# Value Planning Report

## Plan Formulation Project South Utah & Juab County, UT

Workshop Dates: June 24-28, 2024  
Report Date: October 29, 2024

Final  
Value Engineering Study Report  
for

Alternative No.: FC-03

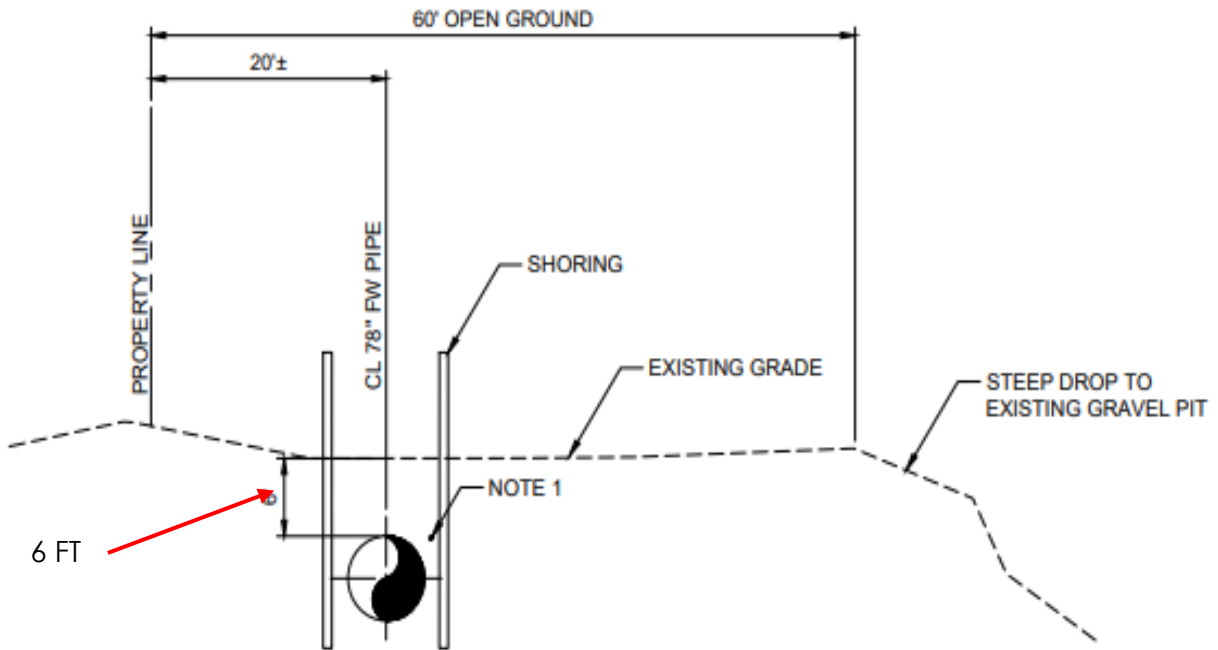
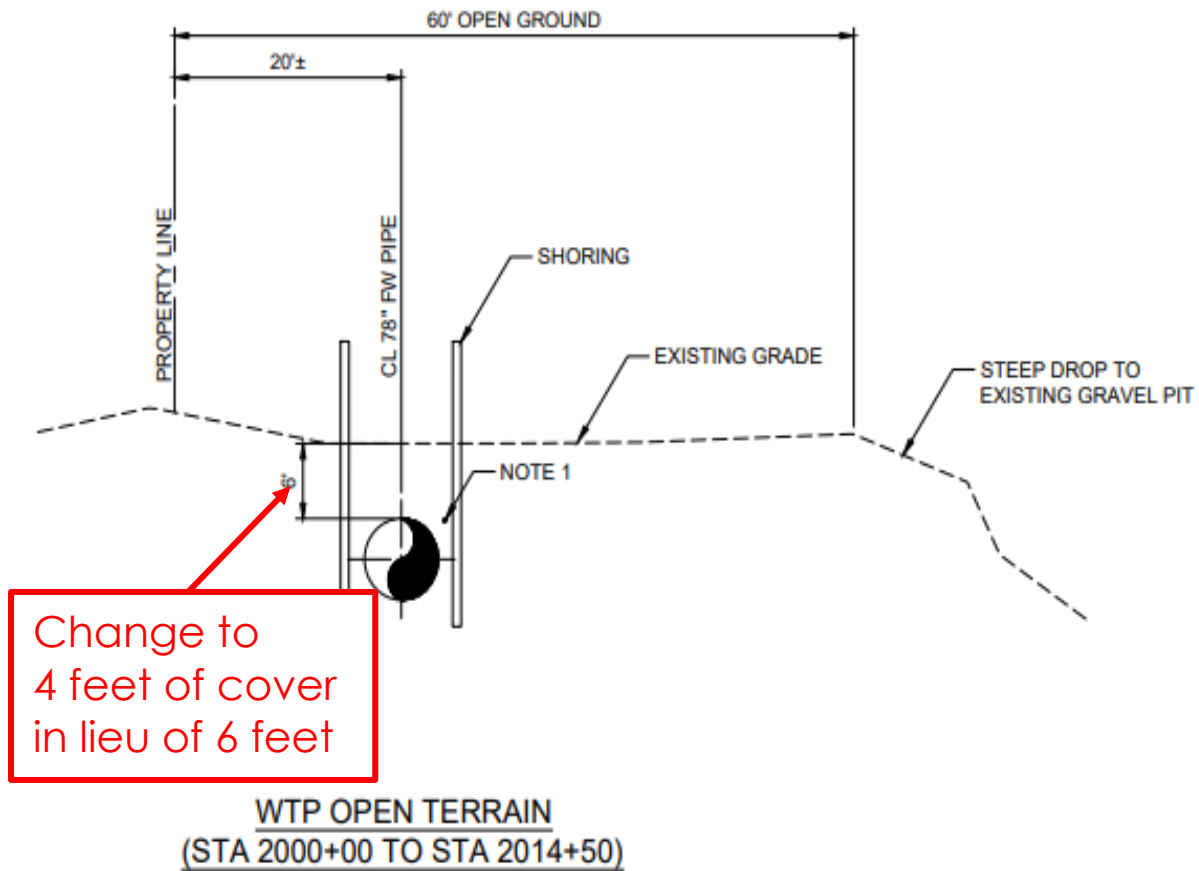
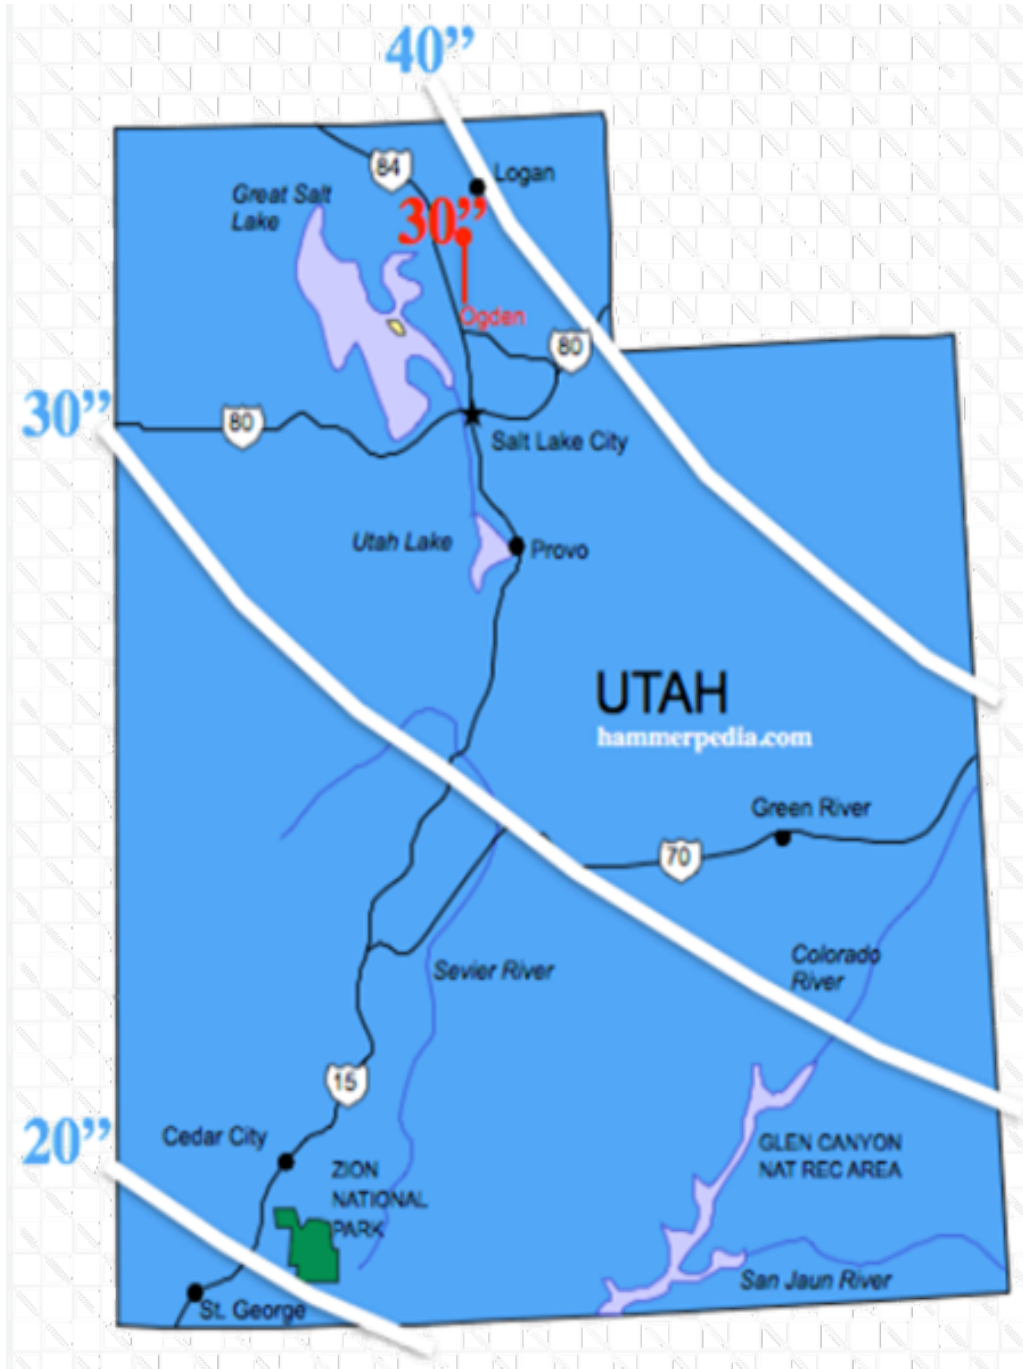
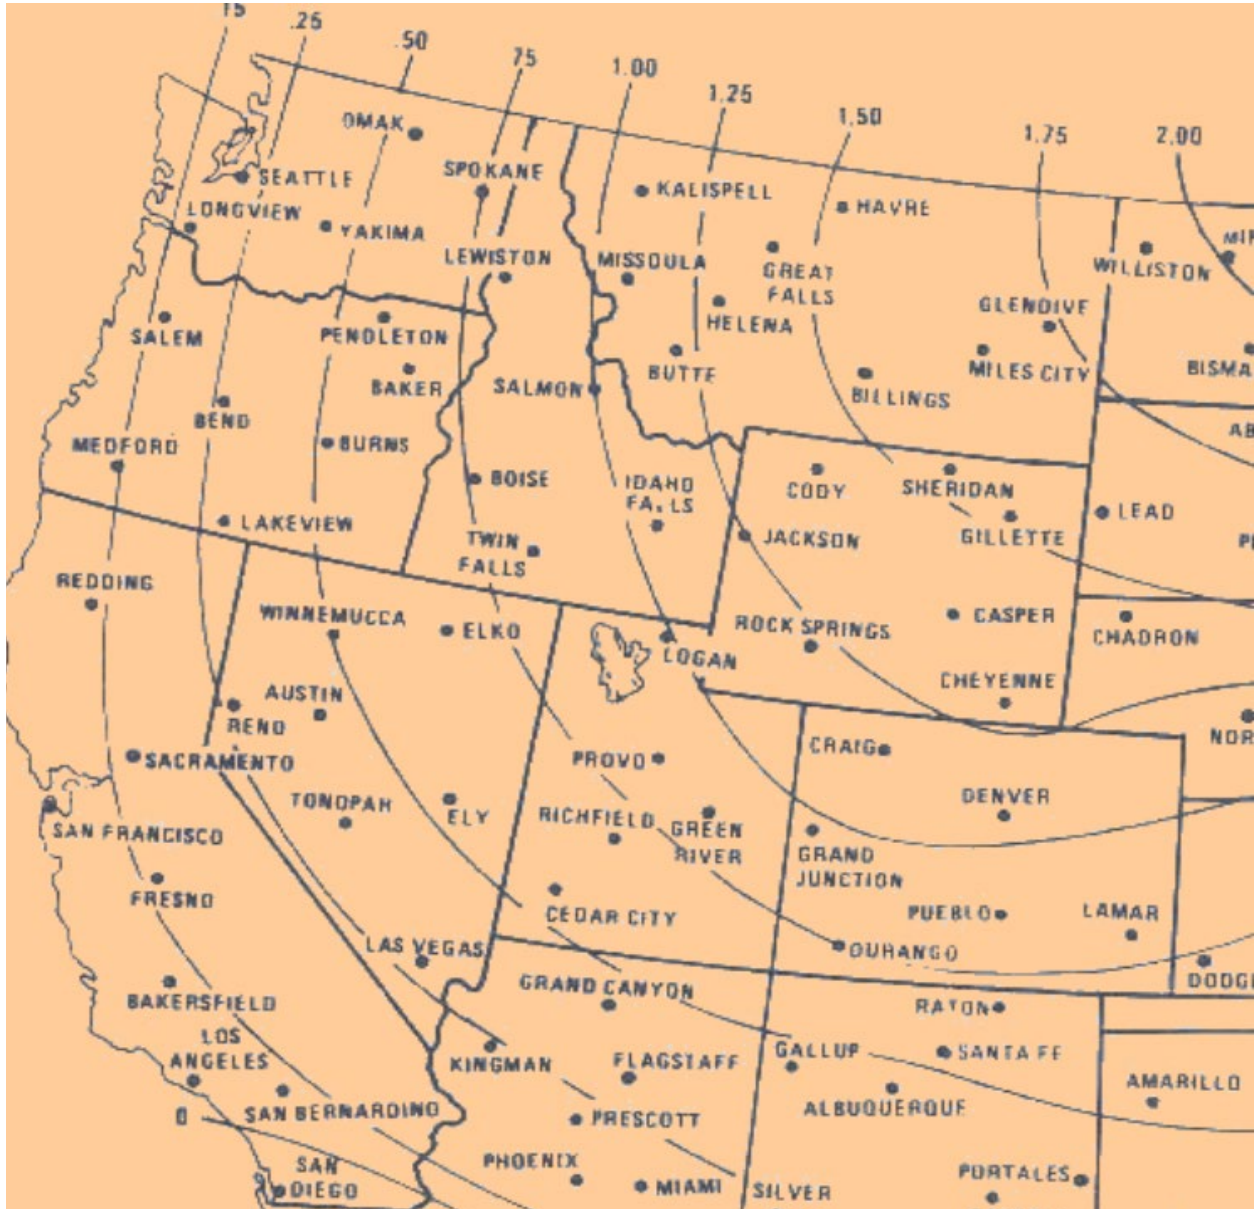
The Value Team suggests the Design Team confirm that 4 feet of cover over the finished water pipelines is acceptable. If acceptable, then the plans and specifications need to be revised accordingly to show this change.

Alternative No.: FC-31

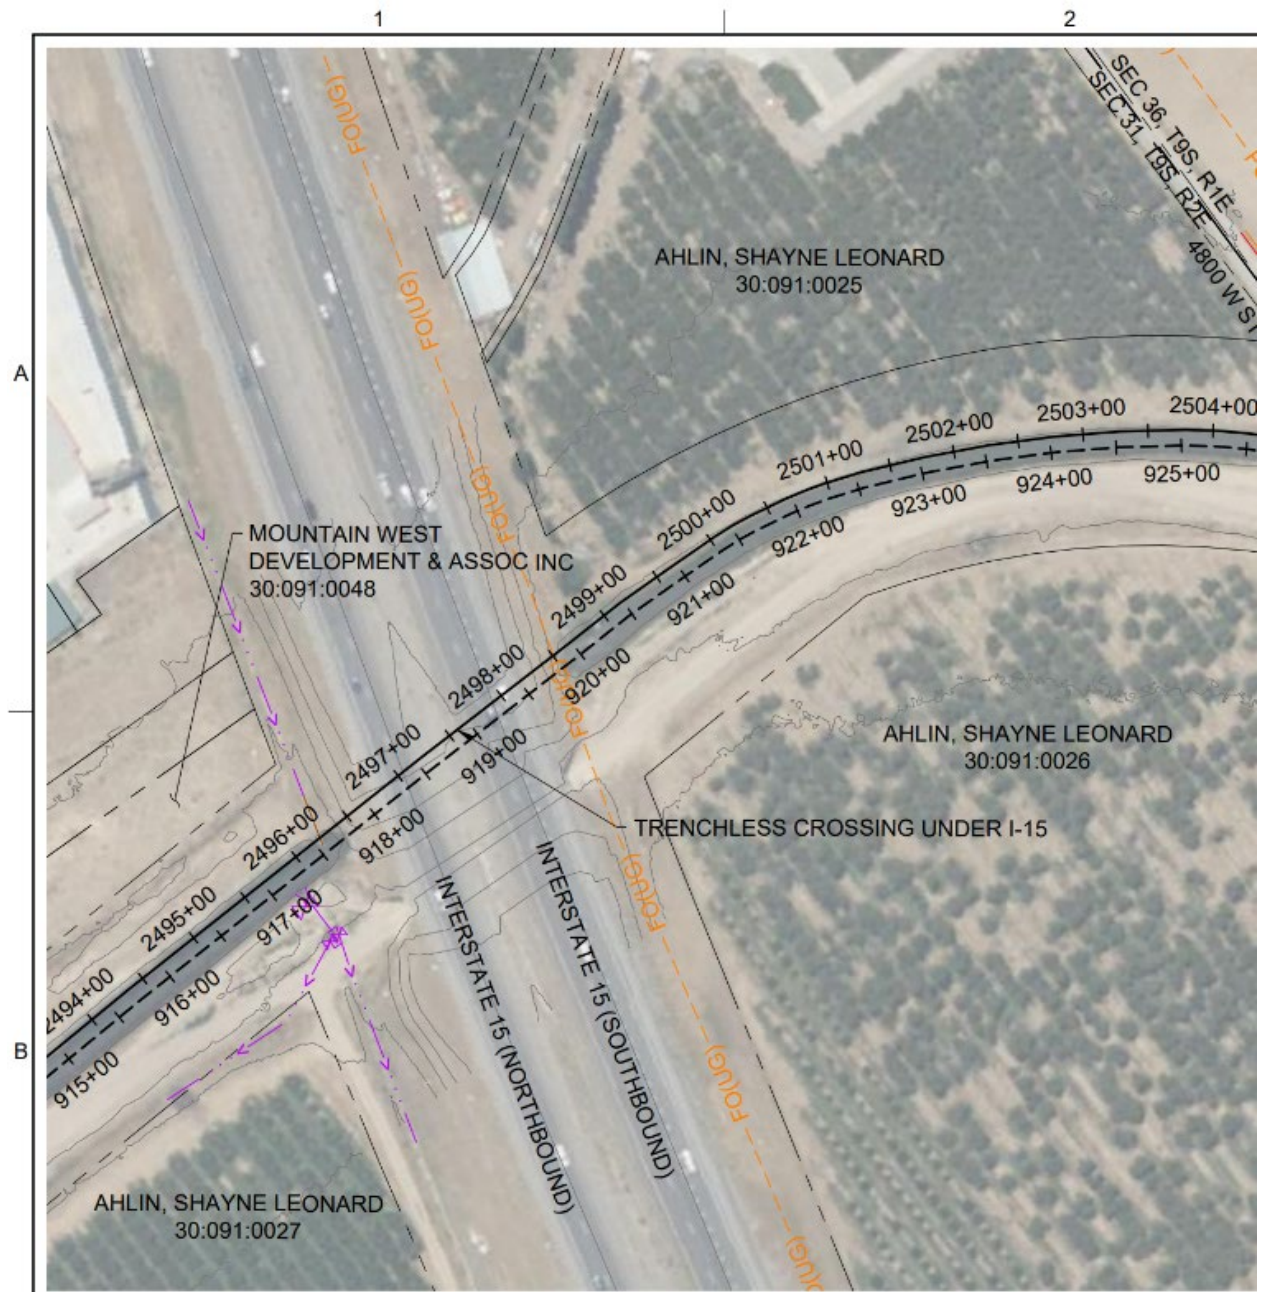
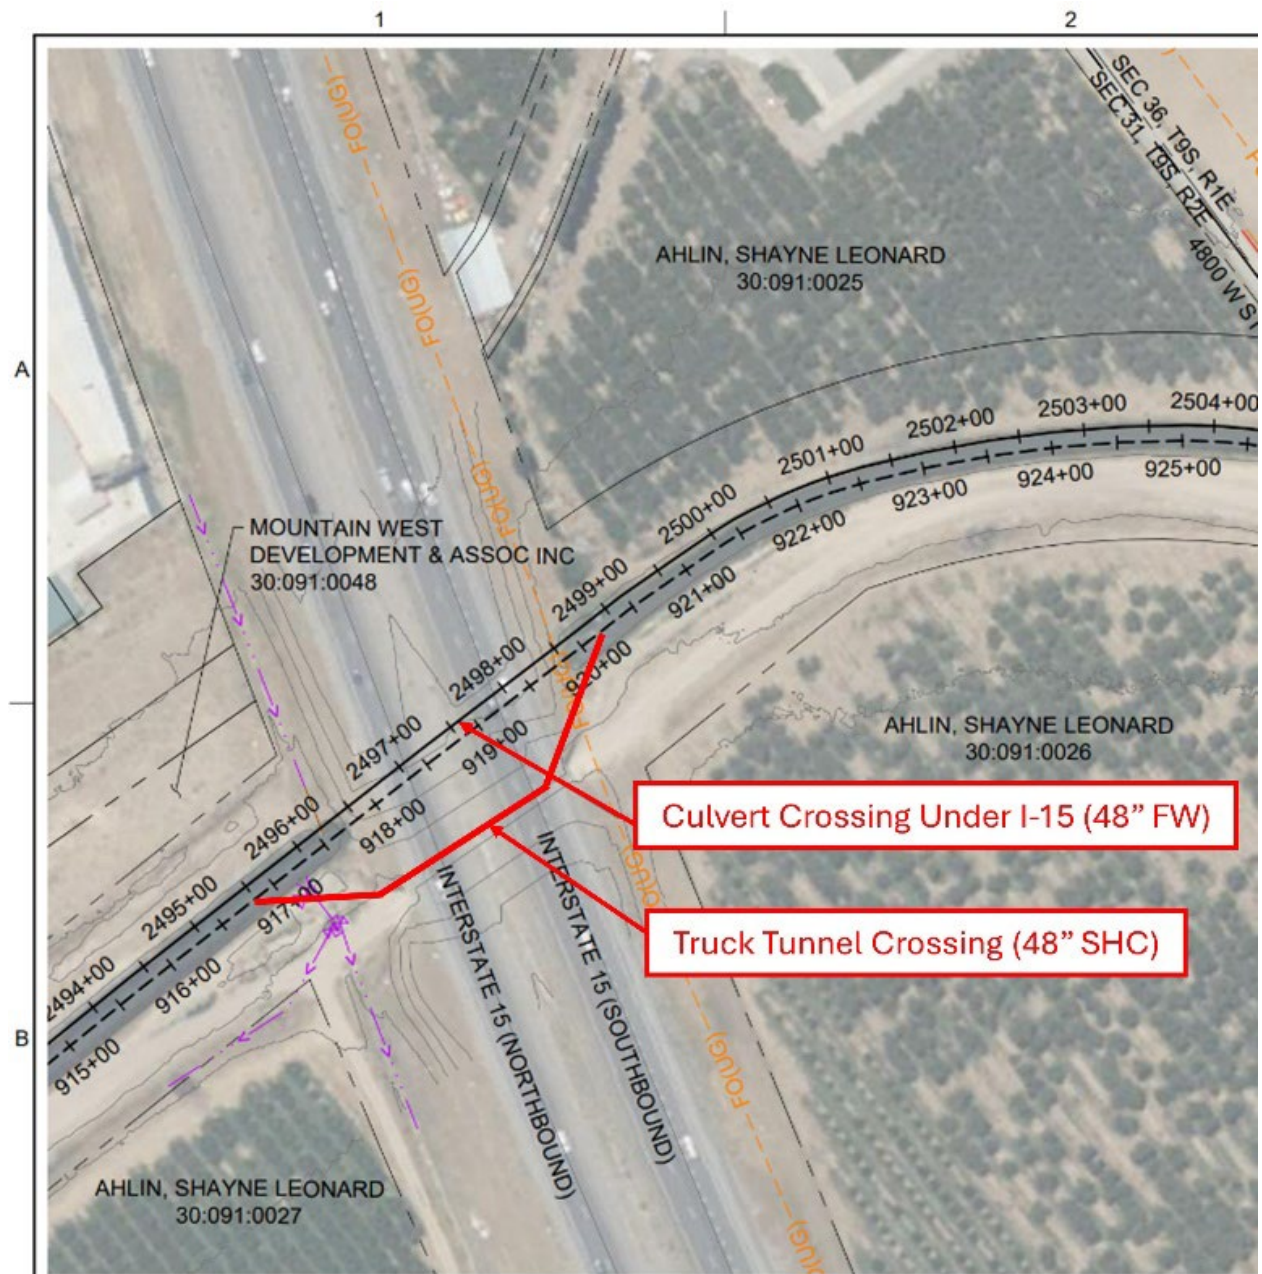
The first step to implementing this idea would be to investigate the footing design of the existing truck tunnel to allow for a 60-inch-deep excavation for the 48-inch HDPE SHC pipeline. Even if structural drawings are available for the truck tunnel, the Value Team recommends a pothole along each tunnel wall to determine the type and dimensional information on the footings. Once the alternative concept is deemed feasible, then schedule a meeting with UDOT to discuss the permitting process. UDOT typically requires a casing for pressure pipeline crossings; however, since this is within the truck tunnel this requirement should be waived. In addition, butt-fused welding of the HDPE joints provides a fully restrained system as well as a leak proof pipeline. Also, the HDPE pipe will be backfilled with CLSM level with the existing roadway through the tunnel.
